City of Surrey  
**PLANNING & DEVELOPMENT REPORT**

File: 7912-0217-00

Planning Report Date: May 6, 2013

in order to permit the development of two business park buildings.

SITE PLAN  
ADP RESUBMISSION

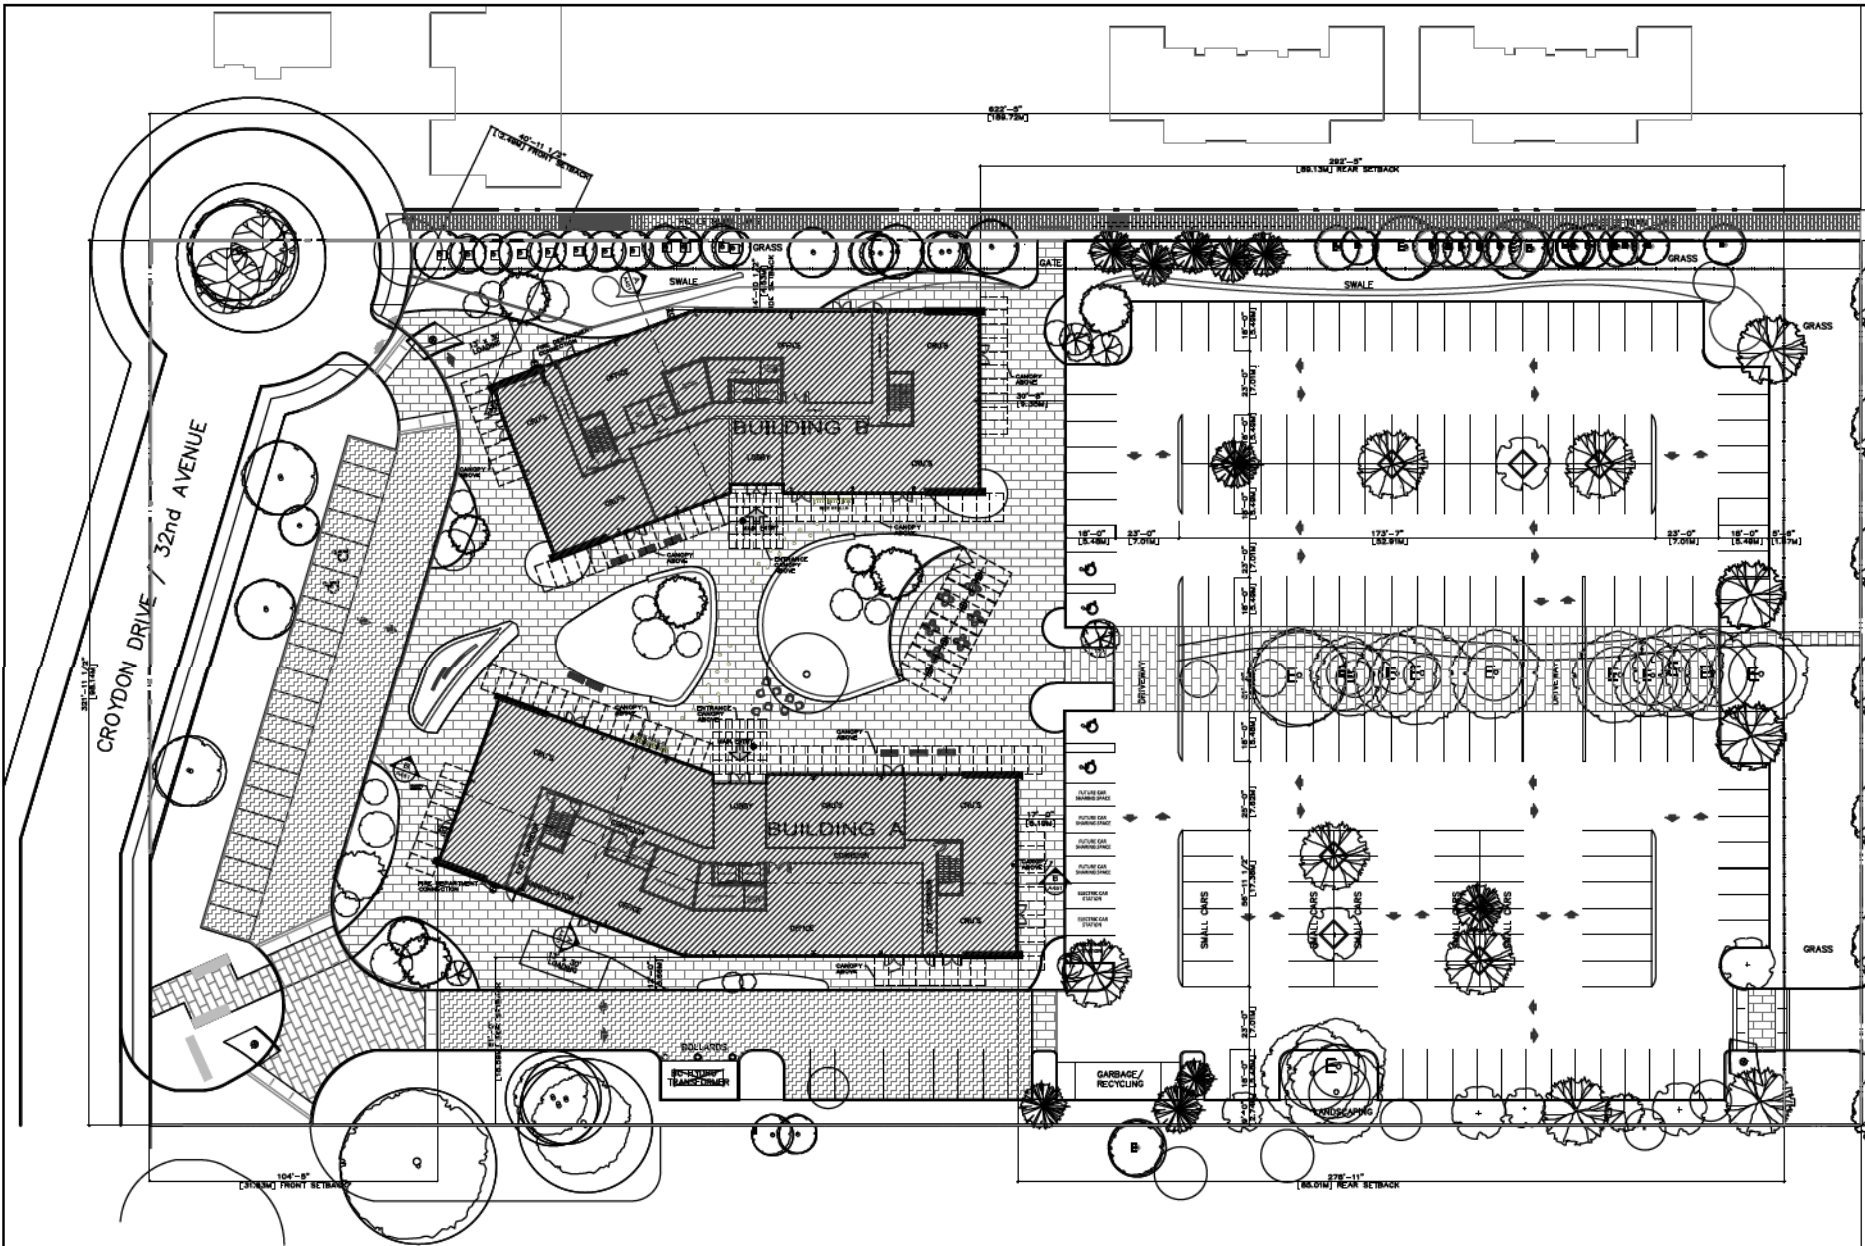
- Site planning is an improved scheme. The site is becoming a 'place' with the centre courtyard and enclosing building forms. Will likely improve the lease plan.
- Could consider not having a crank in the building; leave it as a bar.
- A bow shape now happening; entrances to site are right in middle of the courtyard sides but are where they should be.

- Do more to get glazed canopies to create a cross shaped bows and bring it north.
- Site is still split in half, so drive the row of trees up the middle for a sensational entry – this would join the site together for a distinctive route. If more trees that could be retained in spine it would make a huge impact.

**TITLE**  
 TREE PROTECTION AND REMOVAL PLAN  
 15332 15360 Croydon Drive, Surrey BC

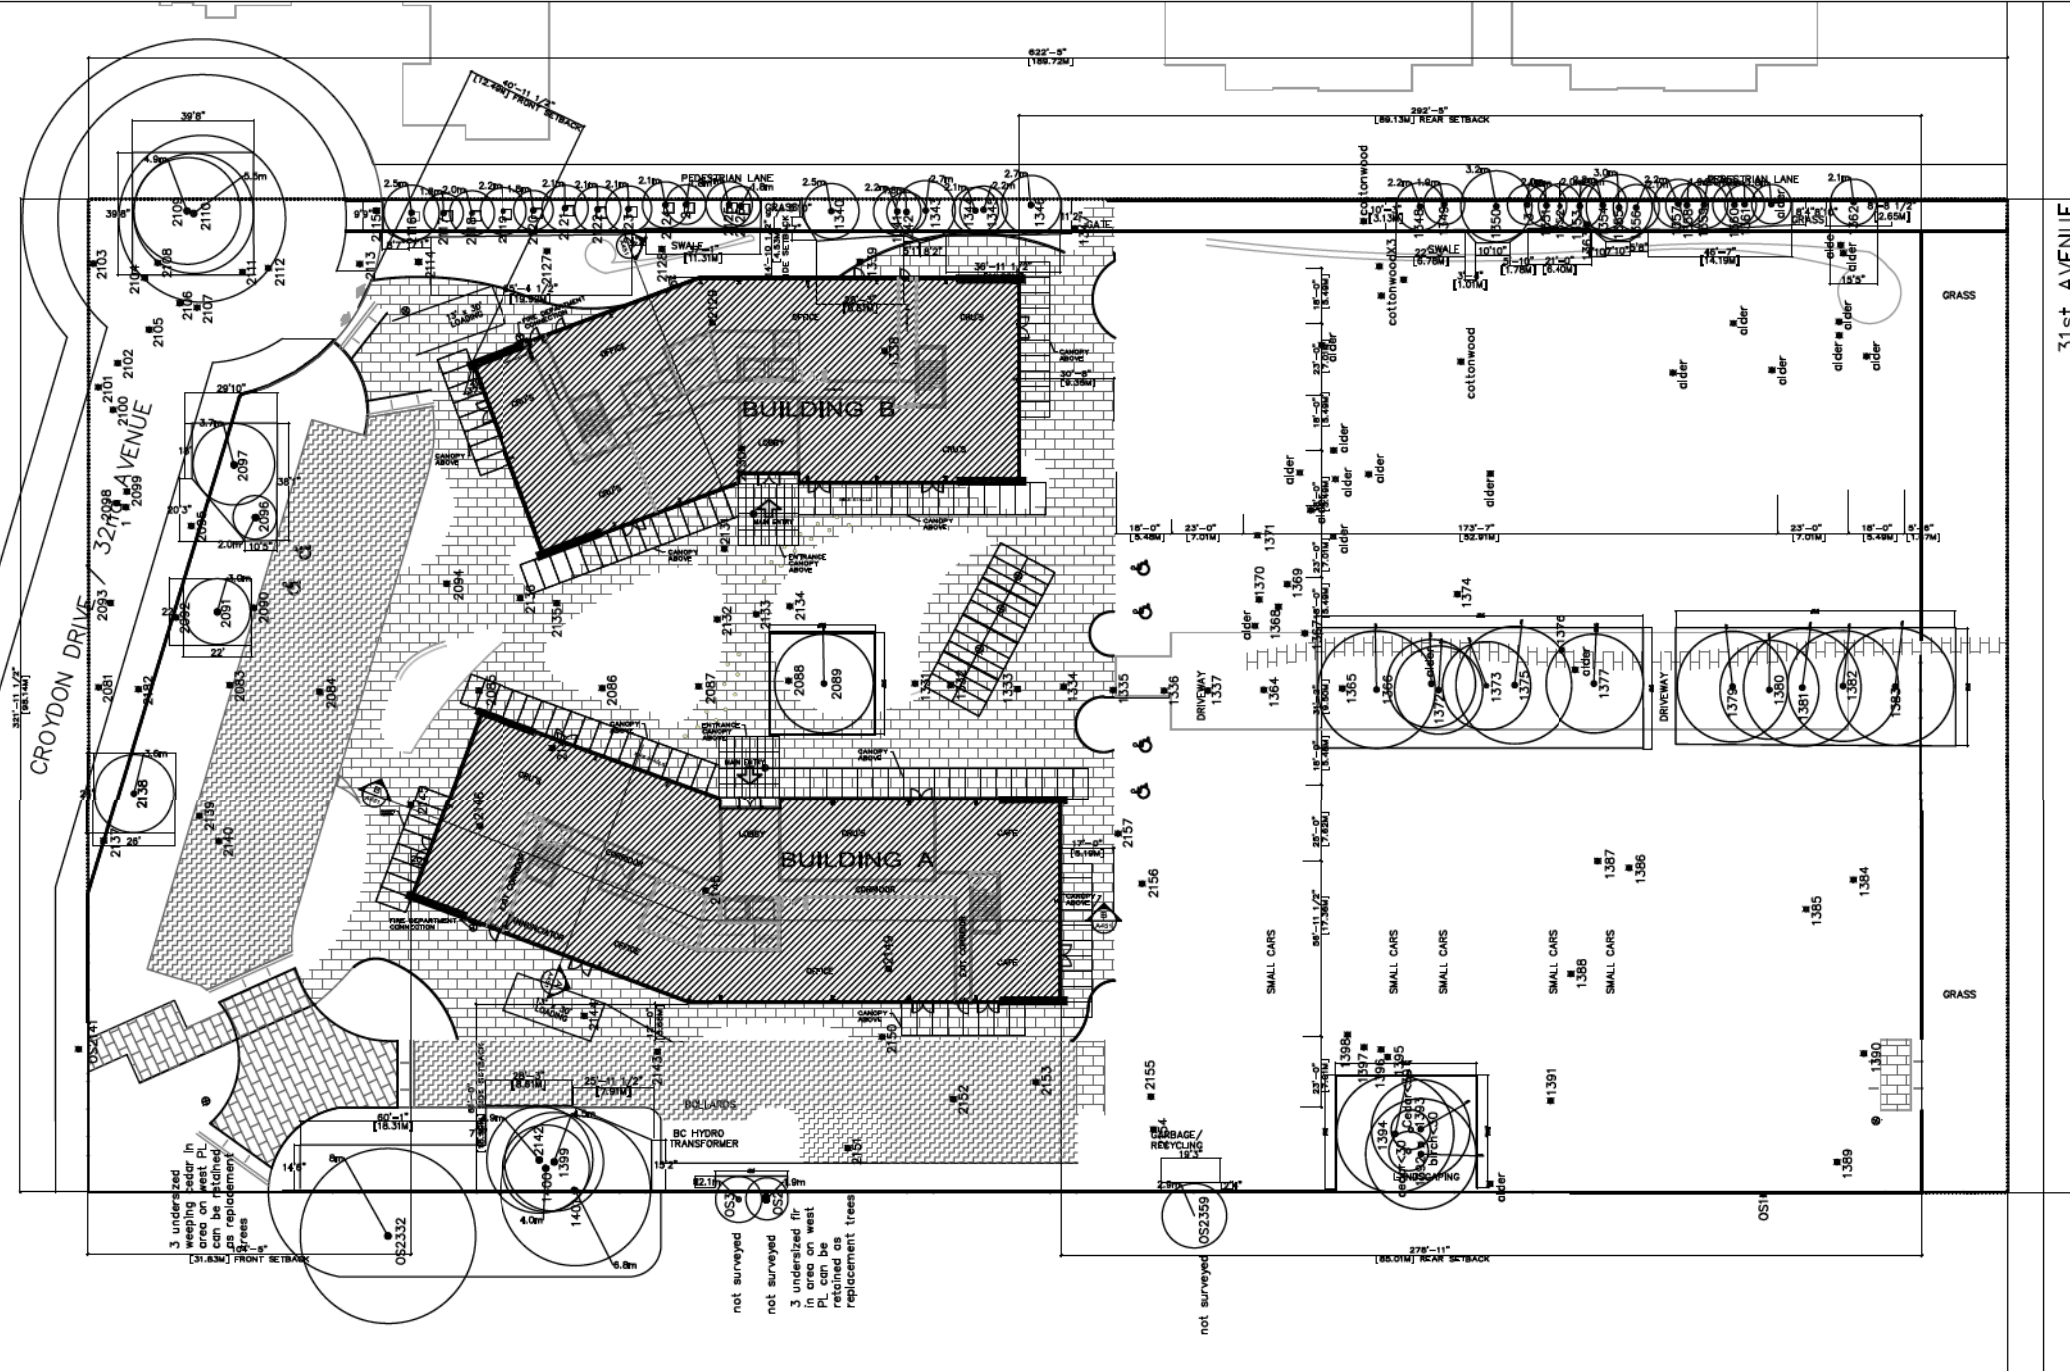
- Good focus on retaining trees. Cost effective solutions for heating and cooling; plant deciduous trees for shading on south and west sides. Trees close to buildings never an issue of views.
